Subject: AP1000 Responses to Requests for Additional Information (SRP9.1.3)

Responses to Requests for Additional Information on SRP Section 9.1.3

RAI Response Number: RAI-SRP9.1.3-SBPA-02
Revision: 0

Design Control Document (DCD) Revision: Revise Figure 9.1.6 (Sheet 1 of 2 and 2 of 2) as shown below.

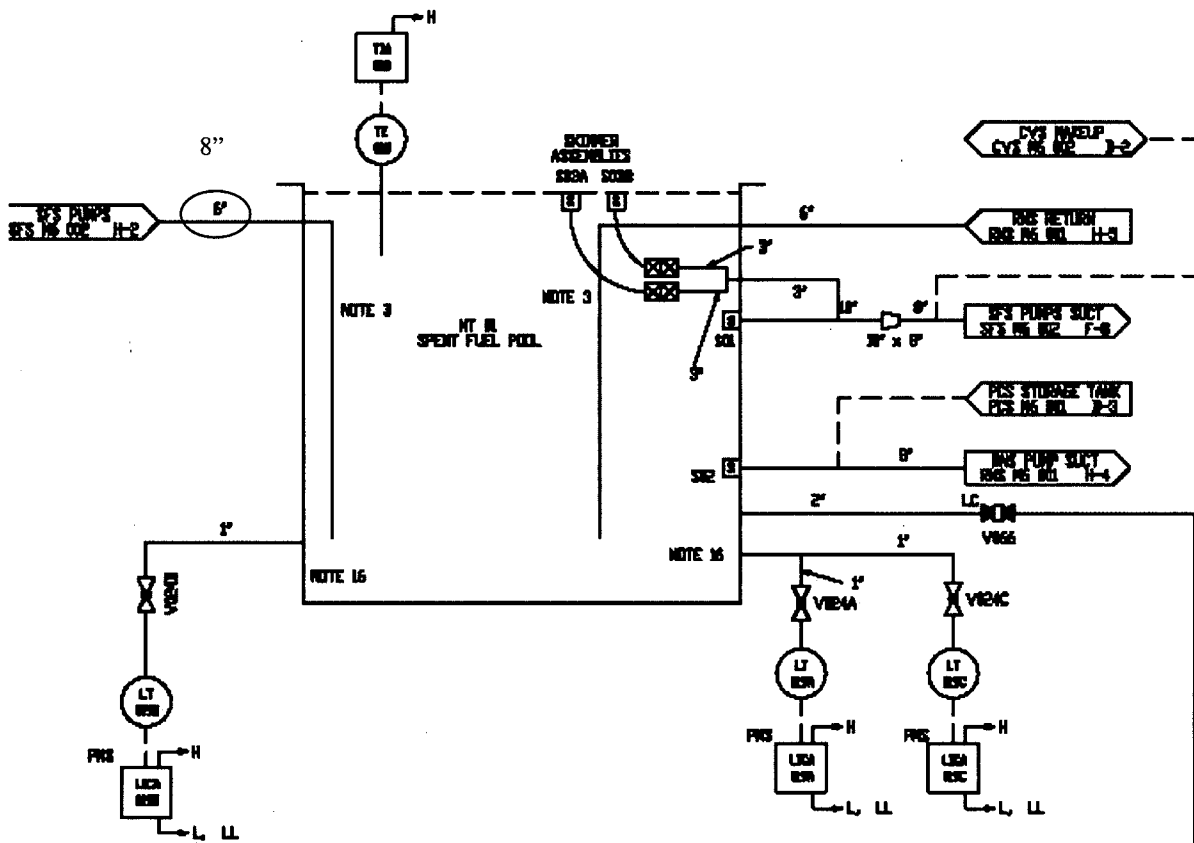
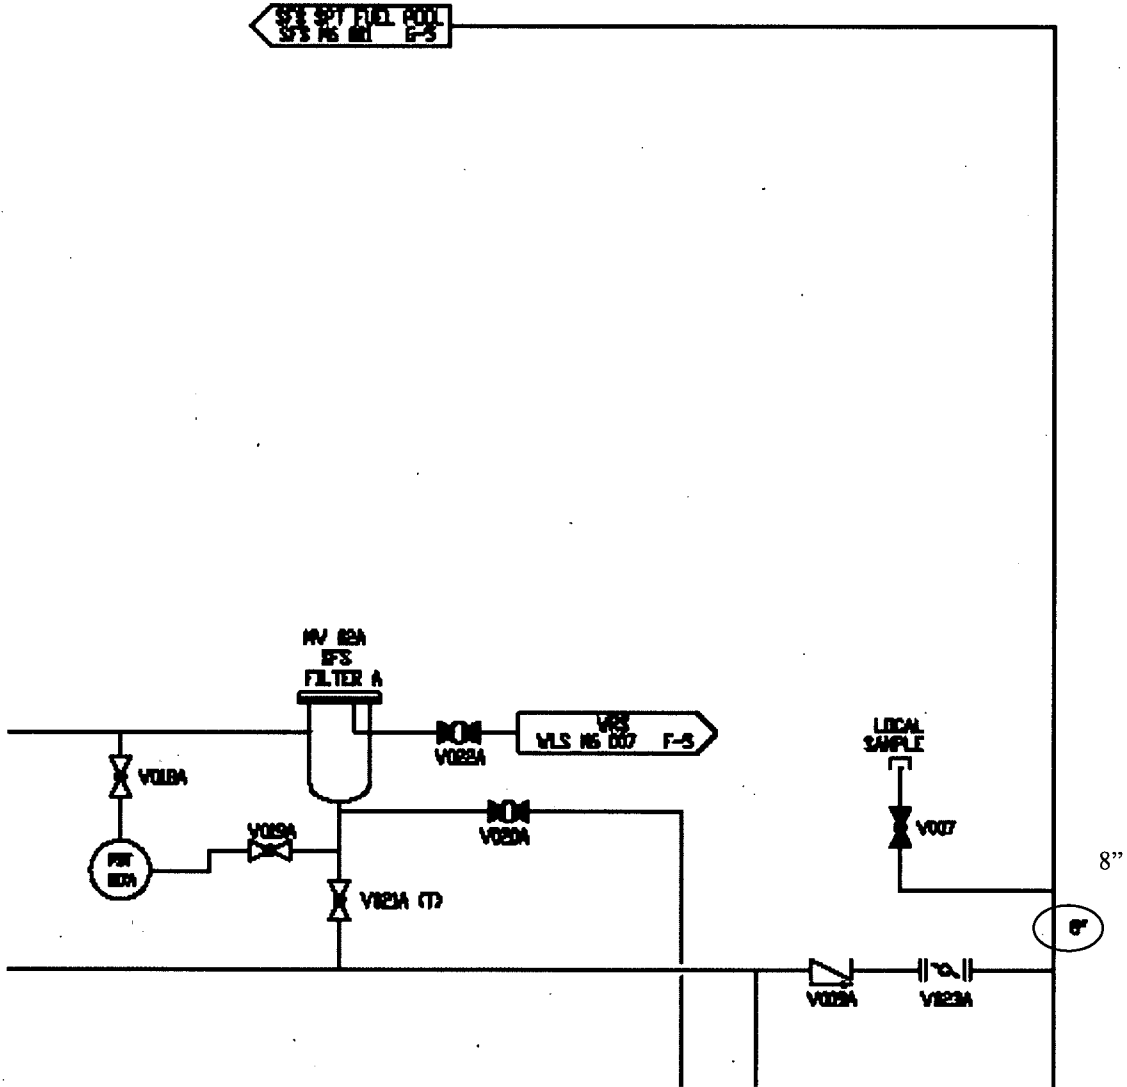
TR-103, Fluid System Changes, Revision 2, page 149 illustrates a change to DCD Figure 9.1.6 (Sheet 1 of 2). This change revises the SFS pumps' common discharge pipe size from 6 inch, schedule 40, to 8 inch, schedule 40. However, no similar change is shown on the matching pipe in the DCD, Figure 9.1.6 (Sheet 2 of 2). These changes have not been incorporated into DCD and these changes are not documented in TR-134, AP1000 DCD Impacts to Support COLA Standardization, Revisions 0 through 3. The staff requests that the applicant update TR-134 to reflect the above mention changes.

The SFS common discharge line is 8 inches as indicated in TR 103. This should have been reflected in Revision 16 of the AP1000 DCD. This will be captured in the next revision of TR 134.
